TECHNICAL BULLETIN

GOT-A-0221-A

Base Material of the Rating Plates to be Changed

GOT2000 Series, GOT1000 Series

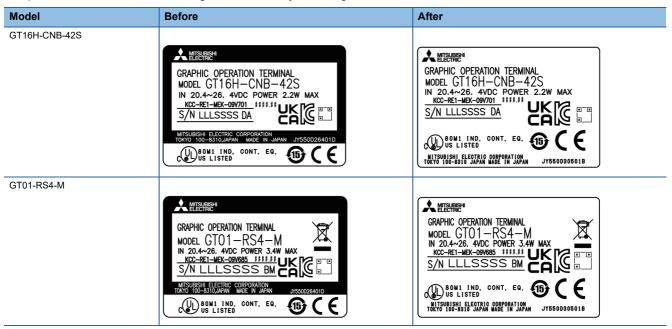
Due to a change in the rating plate's base material, the surface of the plate will be laminated.

Accordingly, the layout of text on the rating plate will be partially changed.

The printed contents will not be changed due to the layout change.
